Figure 6. Proposed 33kV Overhead transmission line

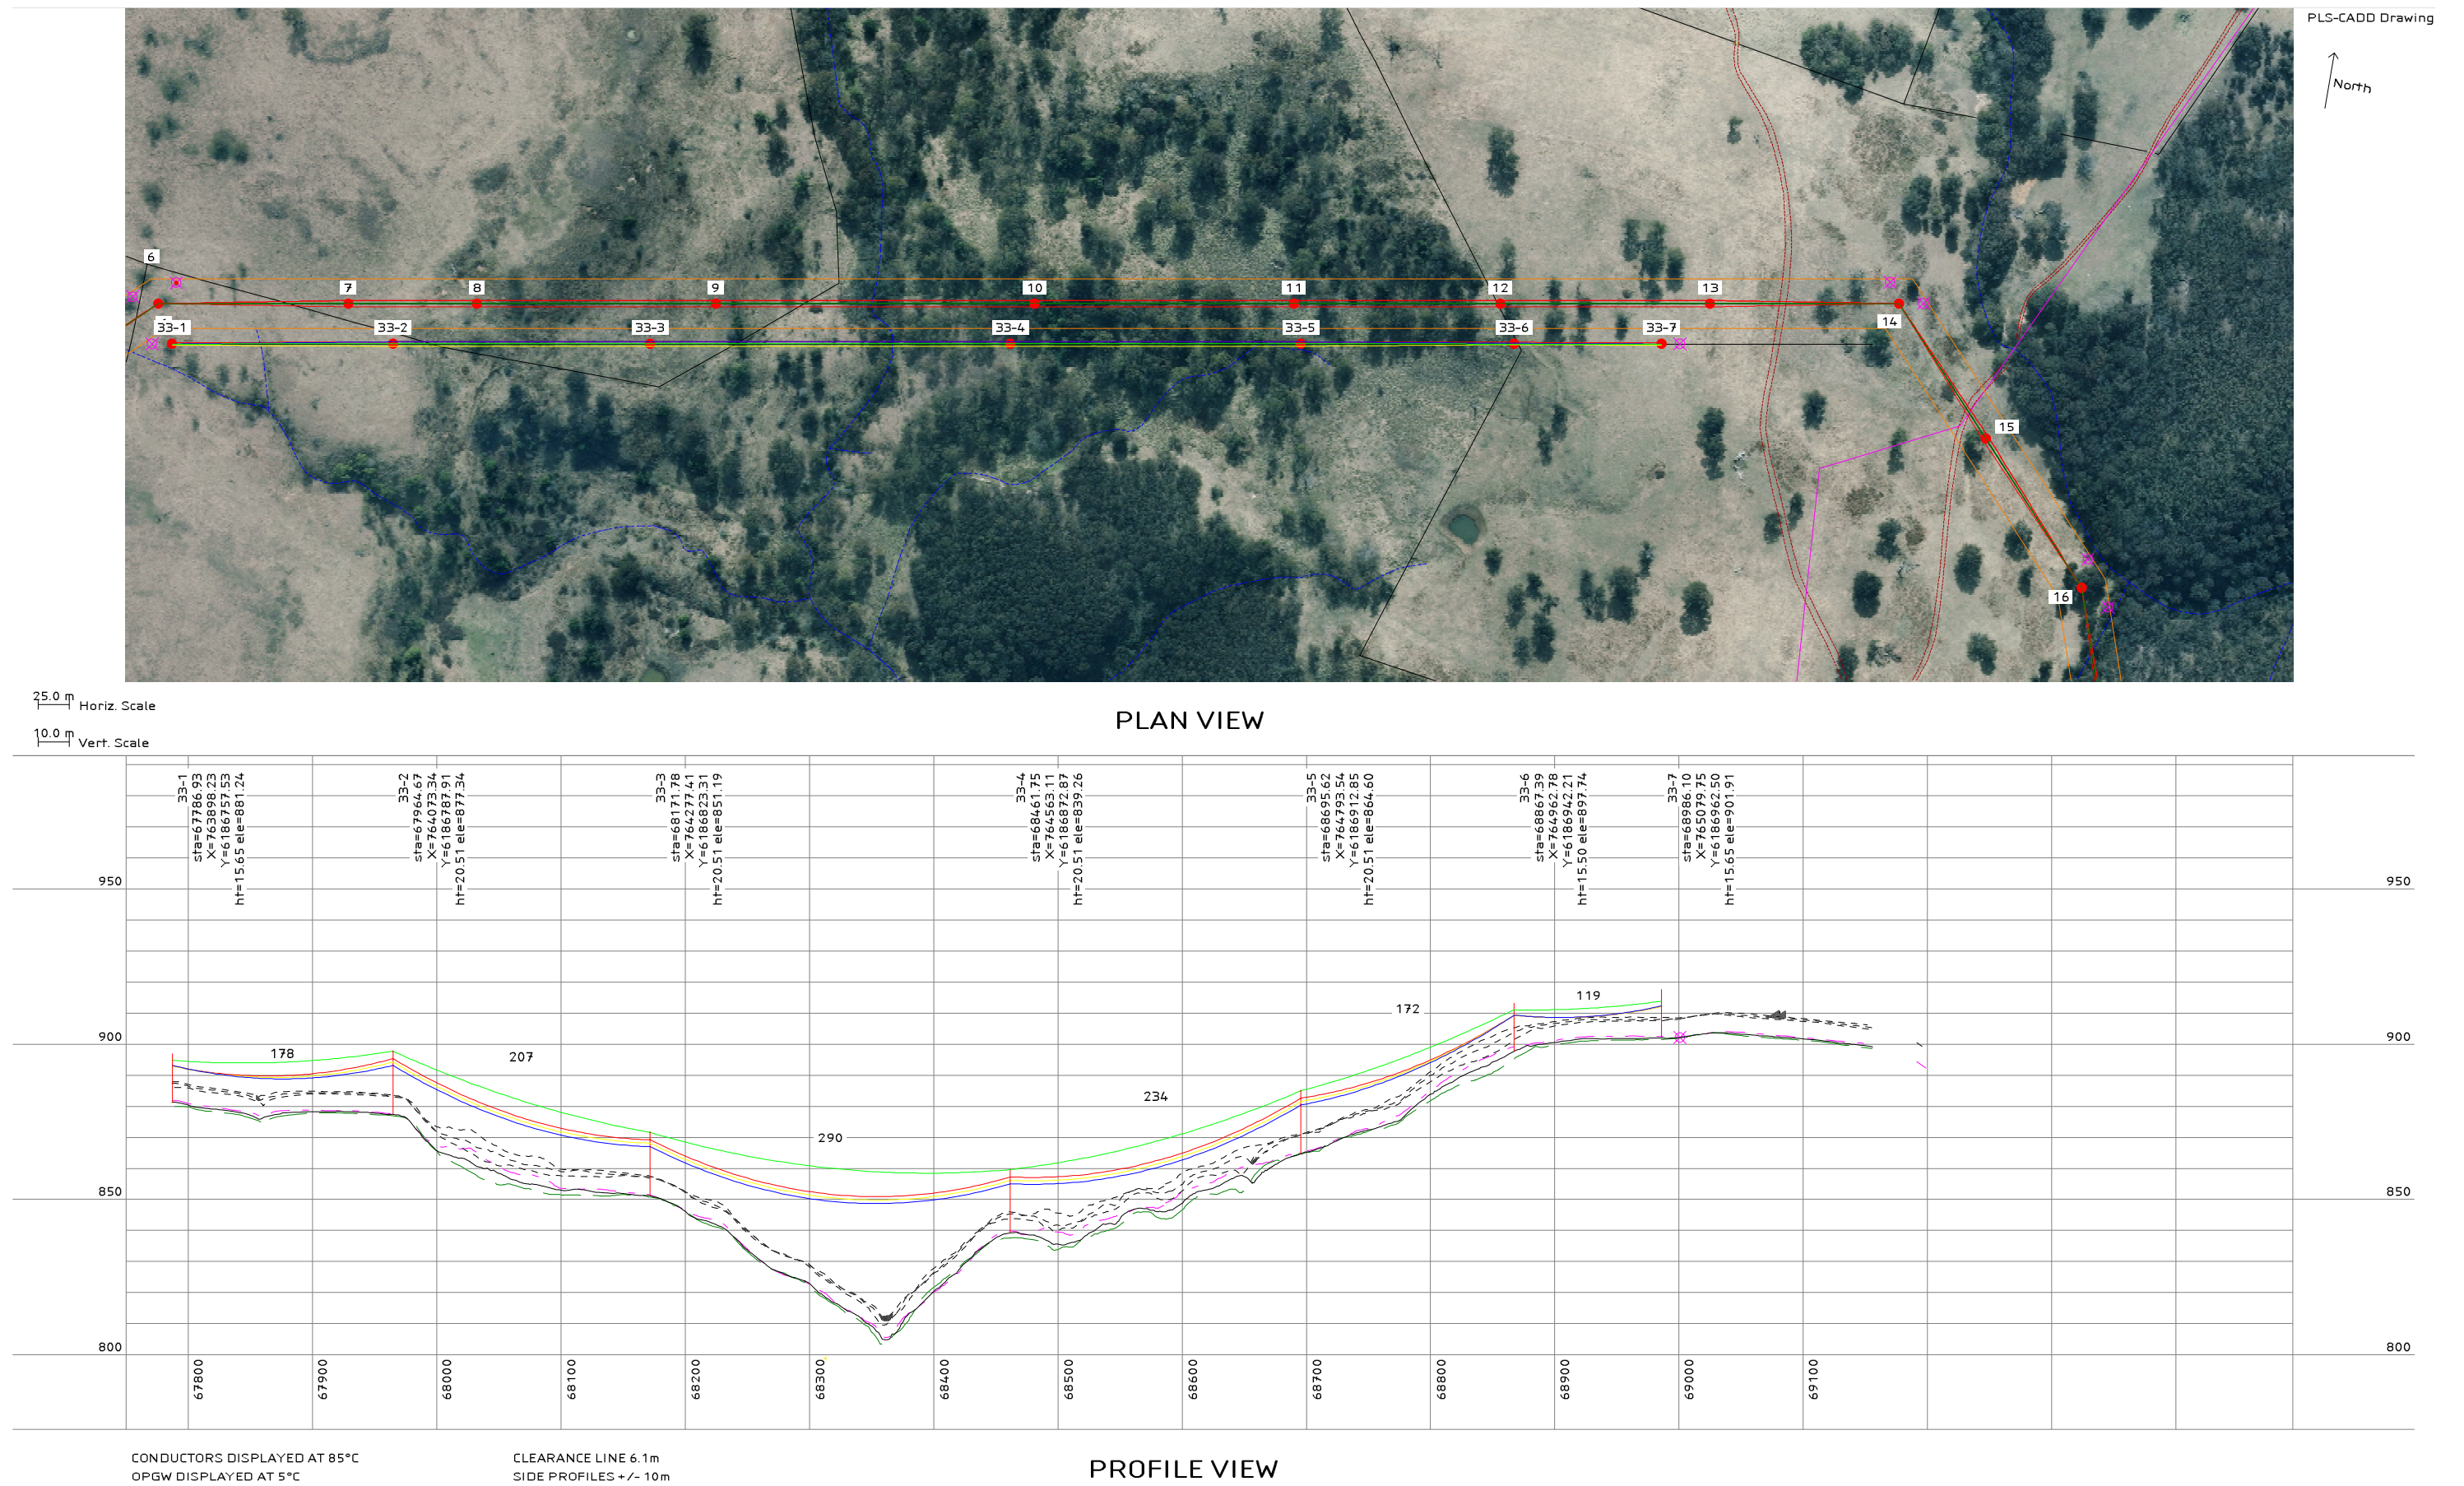
The proposed modified alignment would only require 18.5m high poles with an associated reduction in visual impact. Furthermore, as the topography is suitable, an approximately 800m section of the proposed 33kV line that connects into the substation could be placed underground, similar to the majority of turbine connections within the Project, which would further reduce the visual impact. The section of overhead line would be carried by single poles and the route would include an access track for construction and maintenance to the final pole on both the eastern and western sides of the gully. The steepest part of the gully would be spanned (Figure 6) with no access track required across the drainage line.
